Early Design Guidance 2
8.28.2019
3033617-EG
725 Yesler Way

SECTION 03 / EDG-1 Summary of Board Guidance

Summary of Board Guidance

Podium Ramp Expression

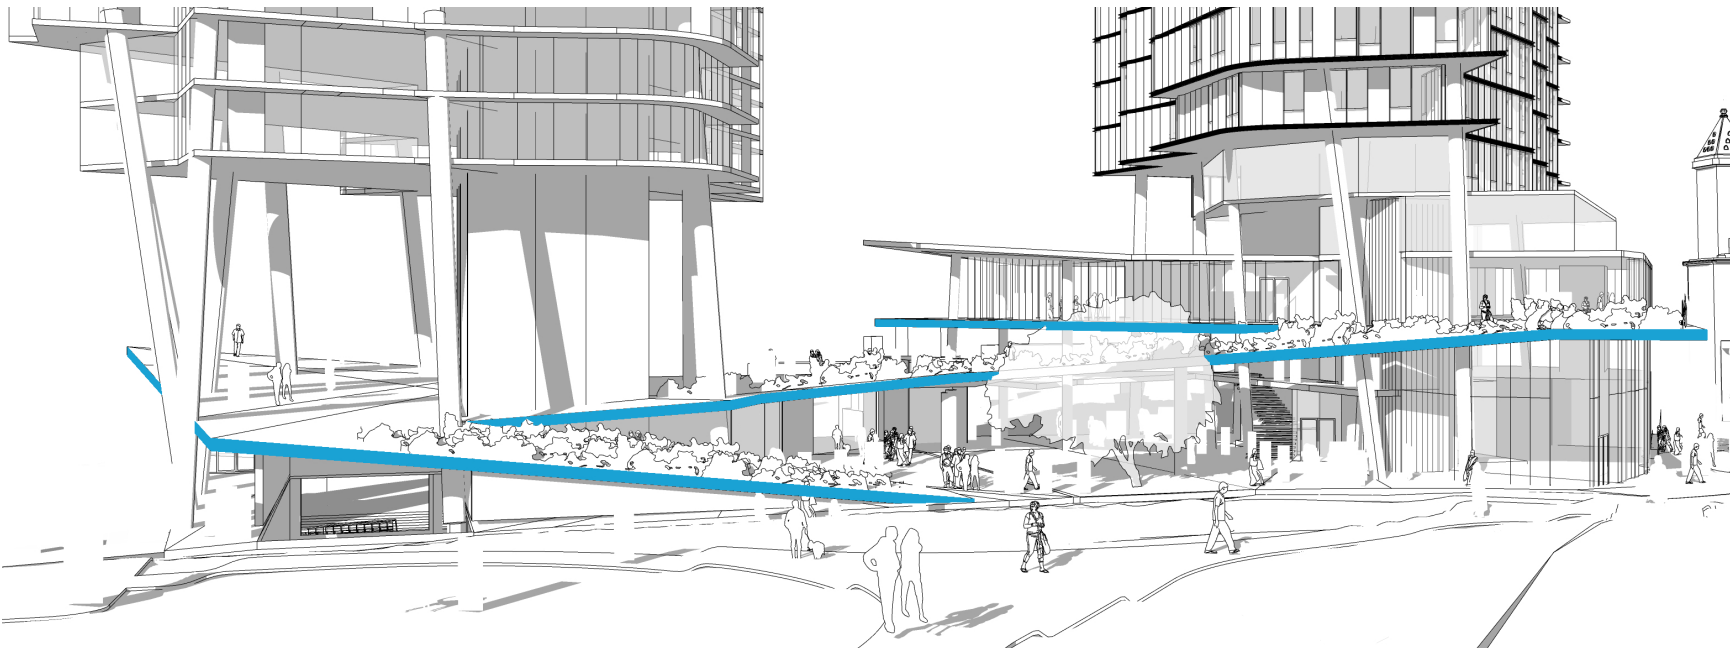
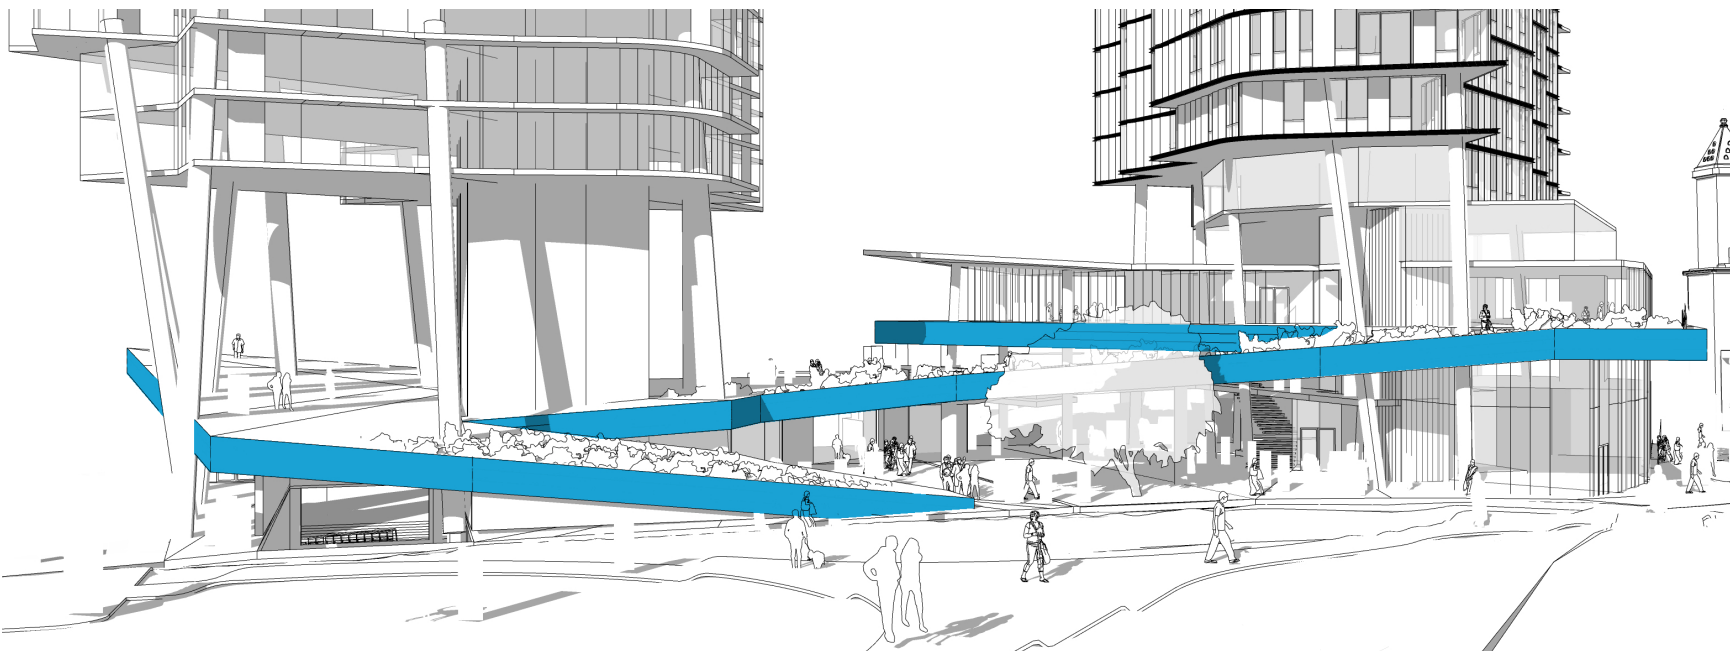
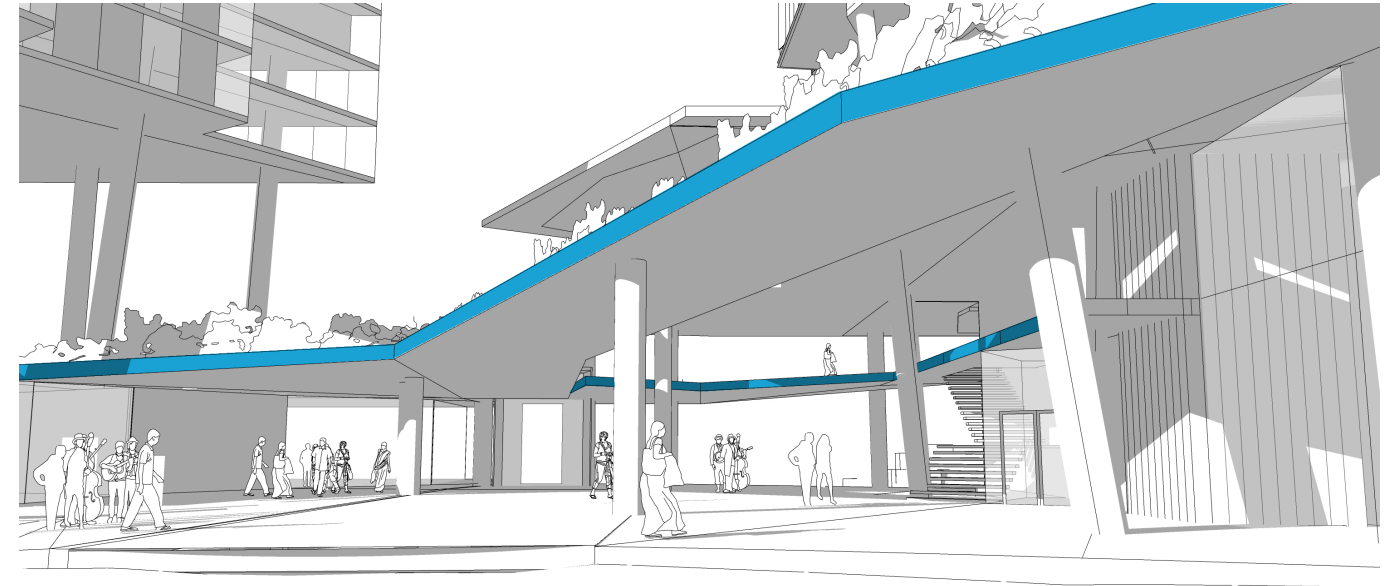
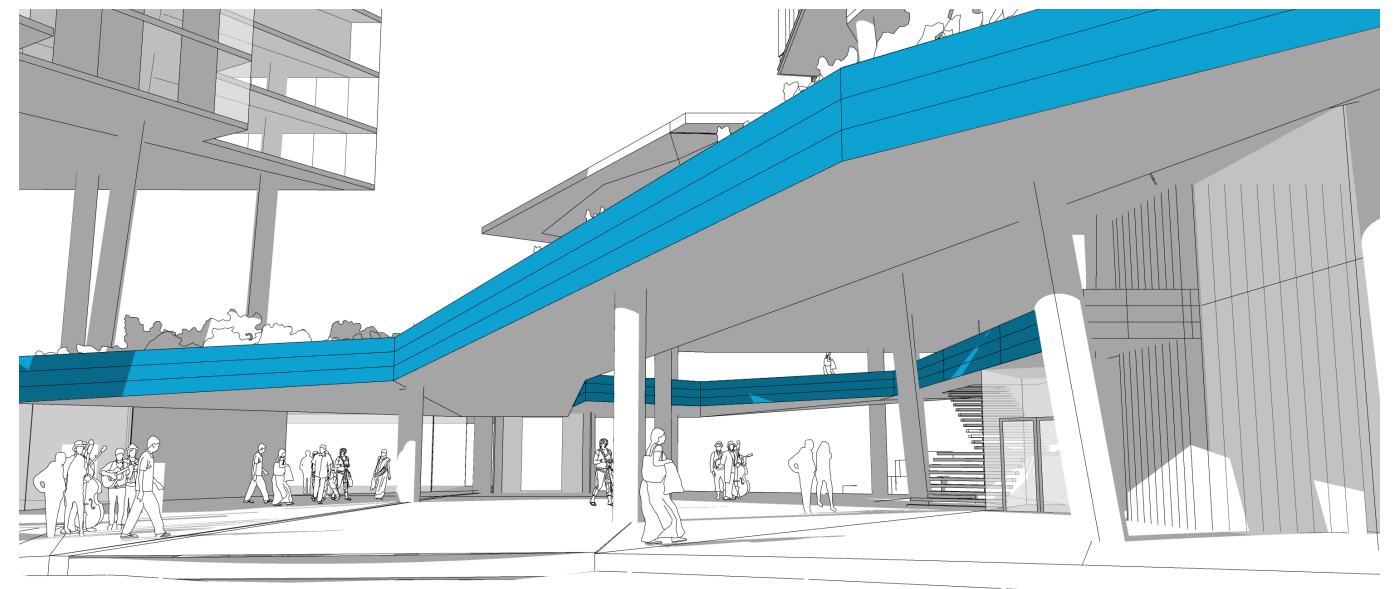
The Board discussed the form of the landscape ramps, suggesting study of heavier bent plate forms to differentiate the podium from the towers, and read as an extension of the ground plane.

The concept for the podium landscaped roof is that of a ribbon of green peeling up from the ground and rising to Level 3, creating a sinuous line drawing people up into the building.

A heavier form of expression has been studied, and was found to feel heavy and slightly imposing on the open space below, while reducing the view apertures, and making access to the west edge seem less inviting to the public.

Simultaneously the concept of openness to the view suggests a light weight expression of the structure to minimize visual obstruction.

The visually heavier tower forms erode and dematerialize into the podium creating an open welcoming environment, in contrast with a traditionally heavy podium base.

The south end of the site and podium is where the expression of the ground mass lifting upwards was developed where it could hold and shelter the open space without imposing on the access, light, and views.

Podium Programming

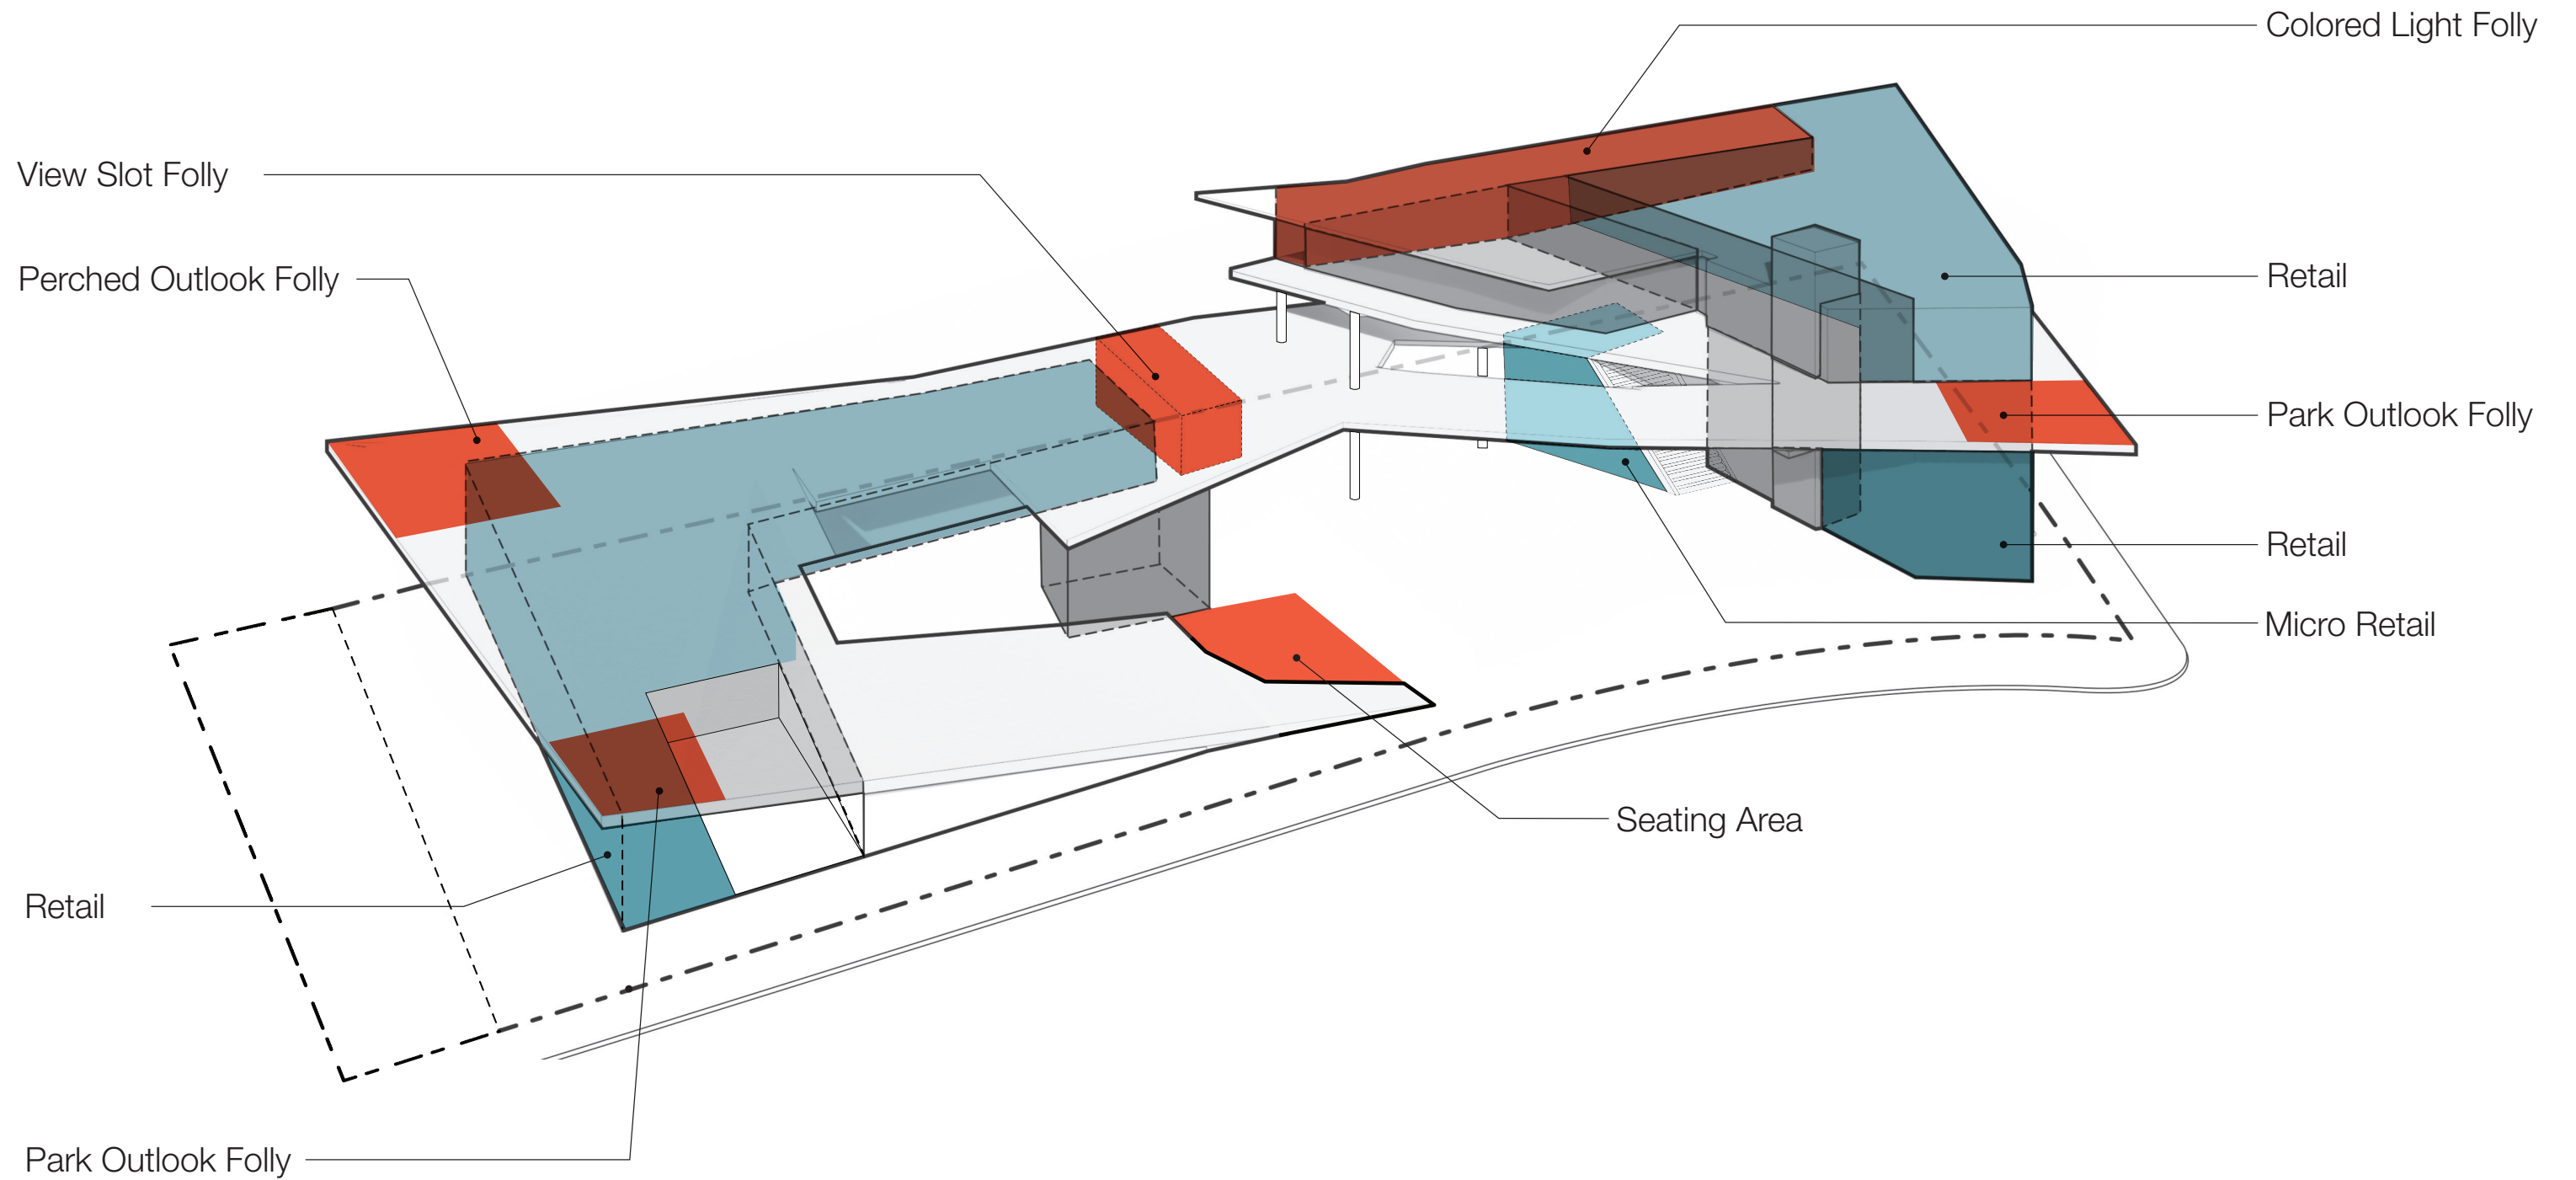
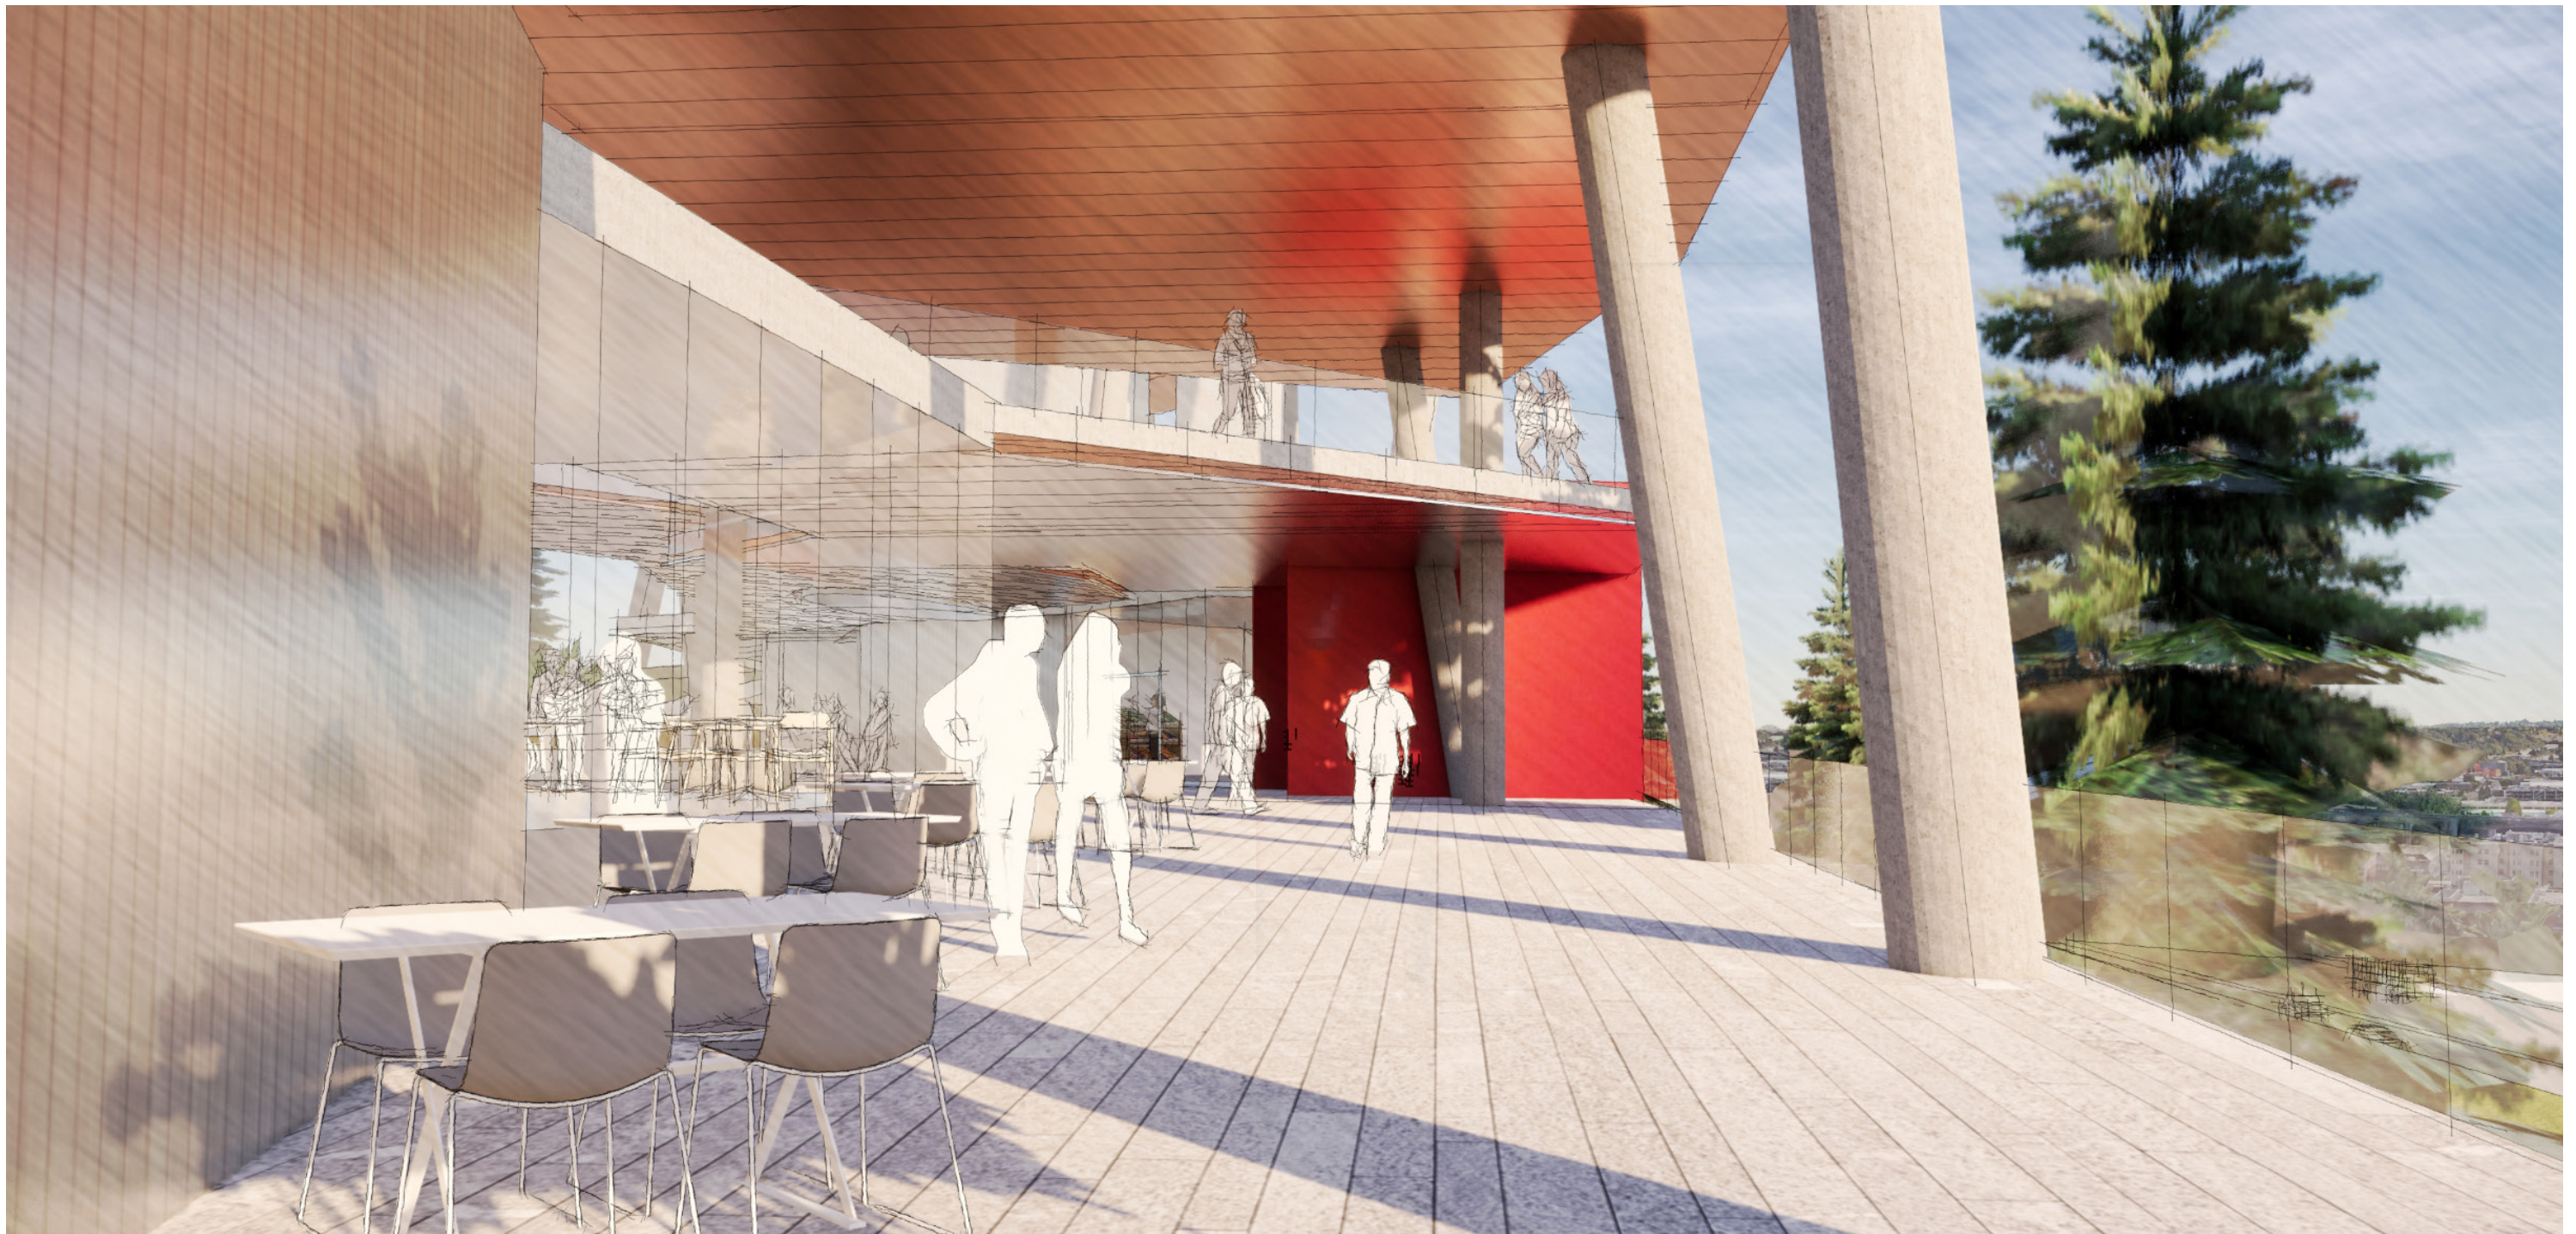
The Board recommended further development of programing at the podium, illustrating how stormwater, art, retail uses, and/or other elements could contribute to the activation and wayfinding; connecting and pulling people up to the elevated open space. The Board noted there should be an element of discovering, welcoming, legibility of the space as public, and address the variety of ages that may inhabit the space. Echoing public desire for small retail, potential market spaces/stalls, the Board suggested limiting the amount of residential amenity fronting the public open space.

Additional images of space that runs under the elevated open space would help the Board understand how the spaces feel.

Programming options on the various podium levels will be diverse in scale and type.

Stormwater concept intends to study how the building run-off from the smaller roof areas can be daylighted in open runnels that wind down the from level 3 and cascade into a rain garden along the east ROW. Opportunities to utilize a gravity system that creates temporal water experiences that reflect the weather shall be explored.

Art and site follies shall be explored to create points of interest in highly visible and accessible locations along the pathway that meanders from the ROW up to level 3.

Retail uses will be strategically located to support activation of the network of open spaces and provide “eyes” on the spaces to increase comfort and safety for visitors and residents.

The open space shall use geometry and elevation to create inviting gathering space options with intuitive wayfinding and clear sightlines to allow visitors to navigate with confidence.

Elements of discovery and seasonal interest will be integral to the open space design details to provide new experiences to individual visitors and residents alike.

The residential lobbies and amenities are pulled away from the corners and recessed to become secondary in nature to the overall open space program, allowing the corridors and prominent gathering and overlook areas to feel open and shared for all visitors.

While not yet fully designed, views within the podium plaza open space have been included to provide a sense of scale and view opportunities. Pedestrian amenities and landscaping are intended to be included and will be shown at Recommendation.
